**3 LYTTON STREET ELWOOD - PLANNING PERMIT
APPLICATION - PDPL/00011/2026**

LOCATION/ADDRESS: 3 LYTTON STREET, ELWOOD VIC 3184
EXECUTIVE MEMBER: BRIAN TEE, GENERAL MANAGER, CITY DEVELOPMENT
PREPARED BY: VIVIAN XU, SENIOR URBAN PLANNER

1. PURPOSE

Figure 8. Extract of the proposed south elevation, including additional dimensions measured by the officer (shown in green).

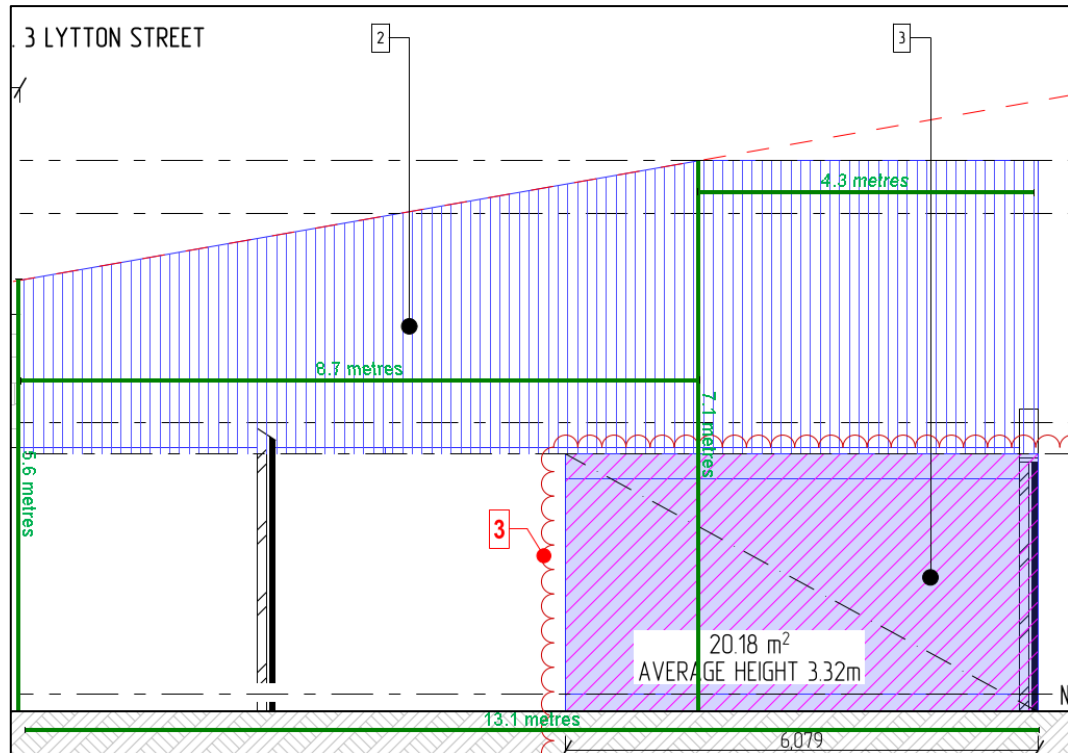
- 11.17 The variation to the walls on boundaries standard is limited to the height of the southern boundary wall. It extends to a maximum height of 7.1m (with the standard allowing a maximum of 3.6m) and an average height of approx. 6.59m (with the standard allowing an average of 3.2m).
- 11.18 Despite these variations, the wall is considered acceptable from a neighbourhood character standpoint, noting that variations of this nature are a common feature within

- 11.19 The proposed variation is also acceptable when considering expected amenity impacts to the approved development at 4 Lytton Street. It is acknowledged that the approved dwelling at 4 Lytton Street will have a courtyard part-way along the proposed boundary wall, and that the proposed boundary wall will extend approximately 0.4m past the boundary wall approved for 4 Lytton Street.

Figure 20. Extract of objector-submitted material illustrating the recommended reduction to the length of the proposed wall on the shared boundary

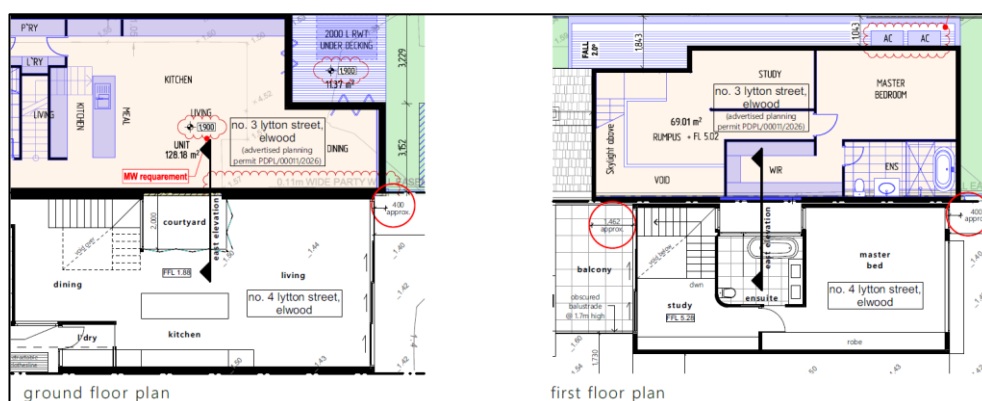
- 11.21 Regarding the additional extent of boundary wall proposed to the rear of the development, reducing the wall on boundary by approximately 0.4m is not considered to result in any meaningful or appreciable improvement to external amenity outcome for 4 Lytton Street.

Figure 21. Excerpt from endorsed ground floor plan for 3 Lytton Street, markup showing kitchen concertina door

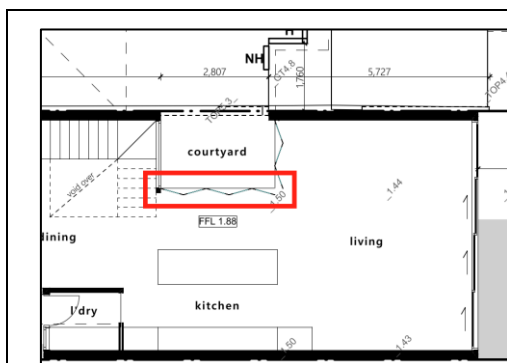
11.39 With respect to the concertina door to the kitchen, and more broadly the siting of the approved courtyard of 4 Lytton Street, it is not reasonable to expect this interface to be protected under this standard. The courtyard is poorly sited opposite an existing boundary wall with the subject site, and results in an outcome which inappropriately leverages maintenance of its amenity off forcing greater setbacks upon redevelopment at 3 Lytton Street. Furthermore, the ensuite overhang above the courtyard has been designed to limit vertical sky access to approximately 1 metre, thereby reducing direct daylight. In addition, the approved ground floor layout includes an additional east-facing living room window, meaning the kitchen window is not the sole source of light to this area.

Figure 22. Excerpt from endorsed ground floor plan for 3 Lytton Street, markup showing ensuite window

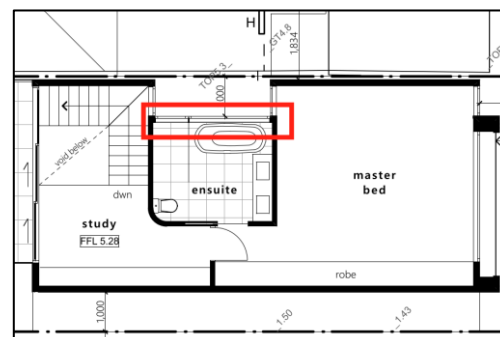
11.40 Regarding the first-floor ensuite window, this window is to a non-habitable room and is therefore not protected by this standard.

- 11.463 Lytton Street is the property at the top and 4 Lytton Street the property at the bottom of each figure below.

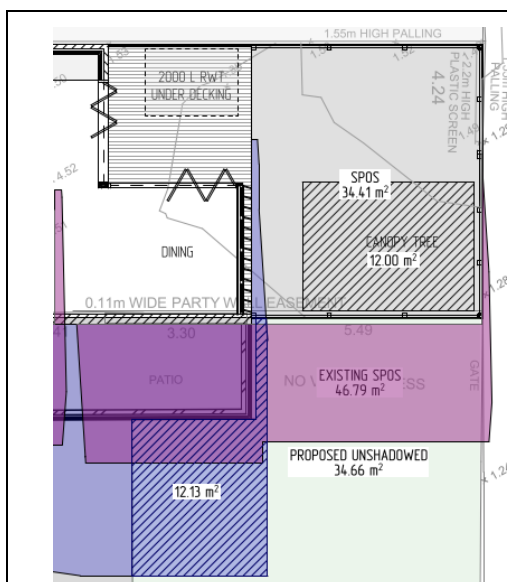
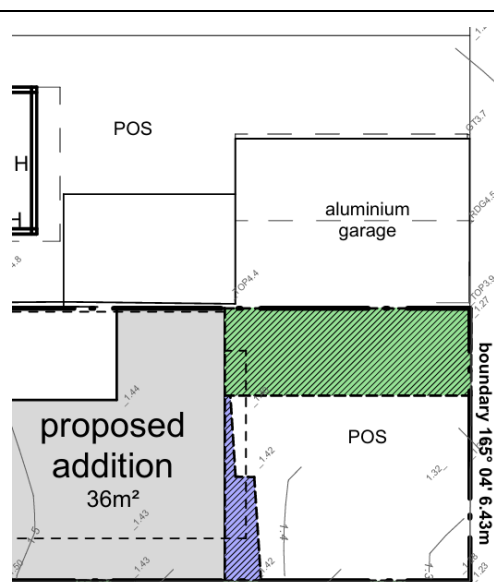
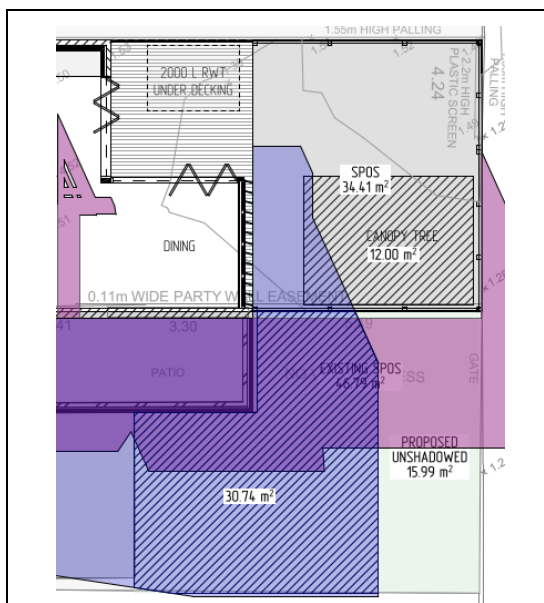
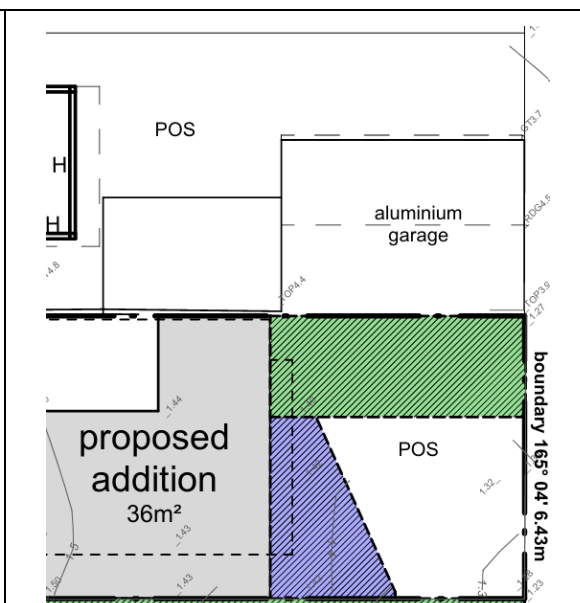
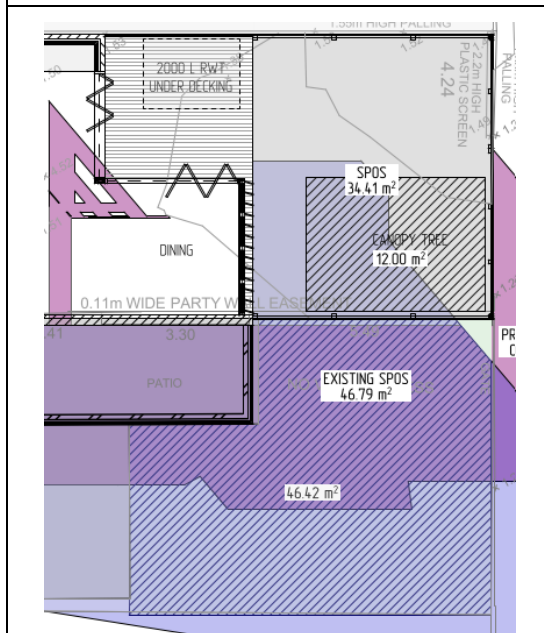
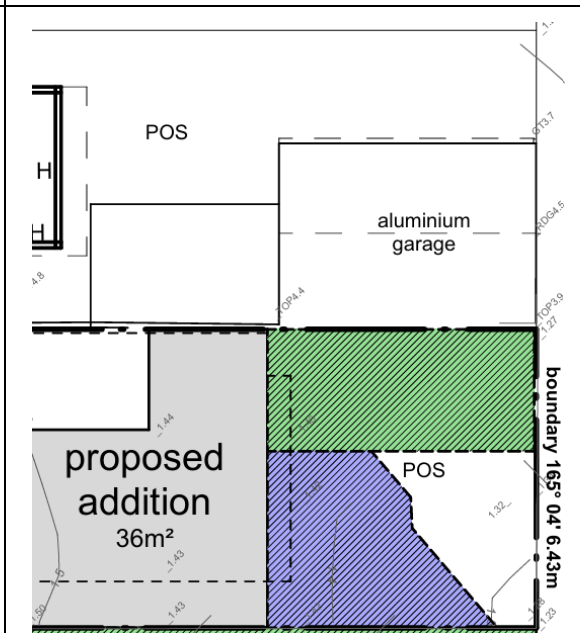
- 11.45 As can be derived from the comparison of proposed shadows for this proposal (left) and proposed shadows for the approval at 4 Lytton Street (right), the shadows cast upon its own SPOS at 4 Lytton Street limits the impacts from the application before us. Additional shadows beyond those already cast will be acceptably minimal at 1pm and 2pm, and while acknowledged the shadows are not insignificant at 3pm, given the limit of the impact during the earlier hours of the day, the outcome is acceptable.

Figure 29. Excerpt of proposed 9am shadow render

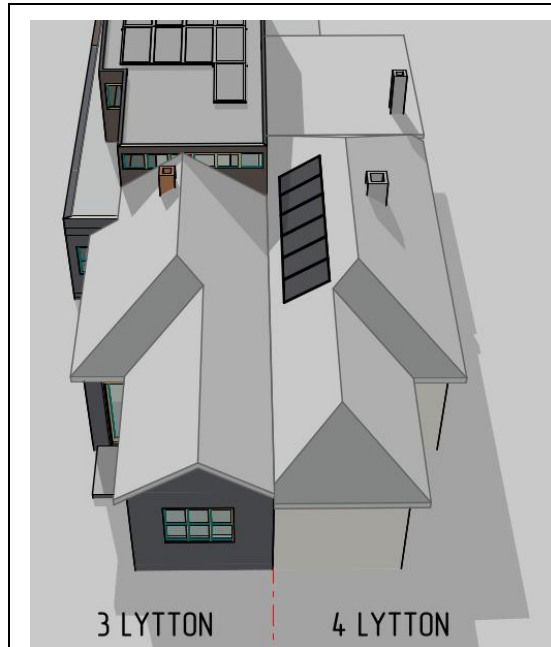
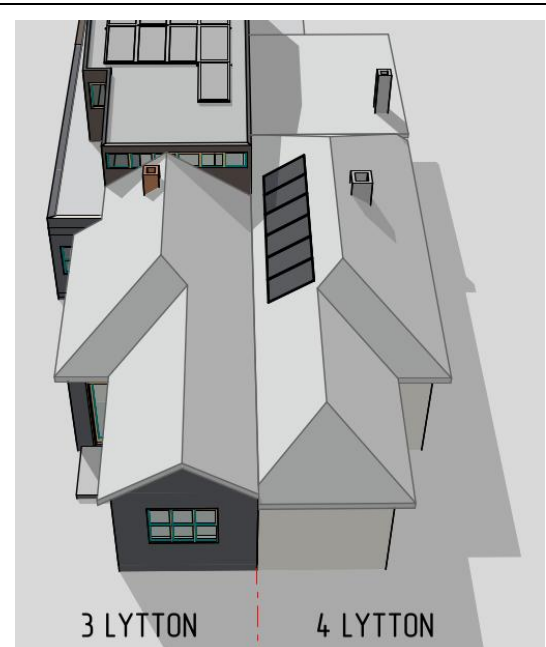
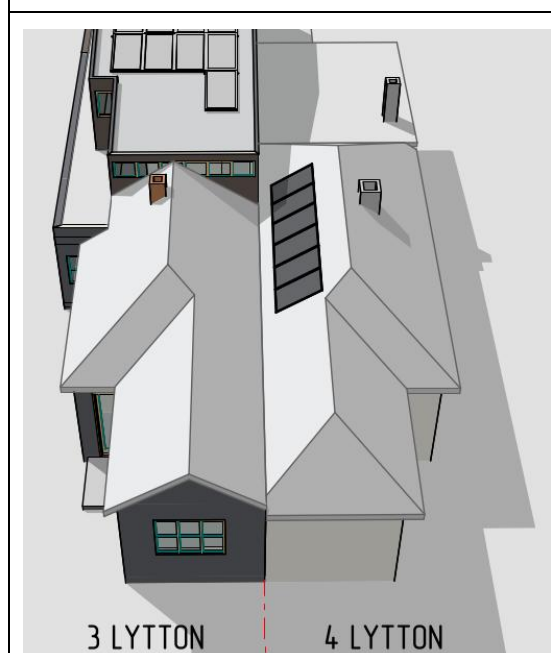
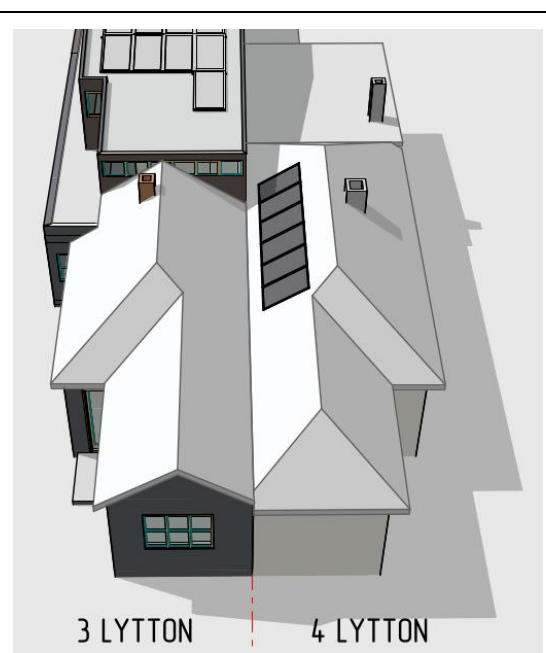
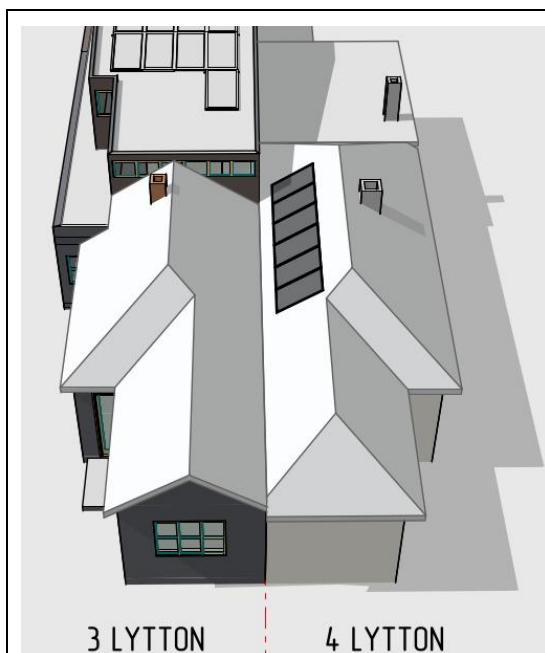
- 11.53The application is supported by proposed overshadowing renders which depict the shadows cast to the solar panels on 22 September, in line with considerations required by the standard. The most affected times are earlier in the day where morning shadows are longest and cast more generally in the direction of the panels.

- 11.54Despite at the most affected time of 9am three of the six panels will be impacted, the impacts are minor and contained to the lower edge of these panels. Throughout the day as the shadows cast move across the panels, this reduces to two impacted panels, and then finally a single panel by 12pm. By 3pm the shadows cast to the single panel are negligible.
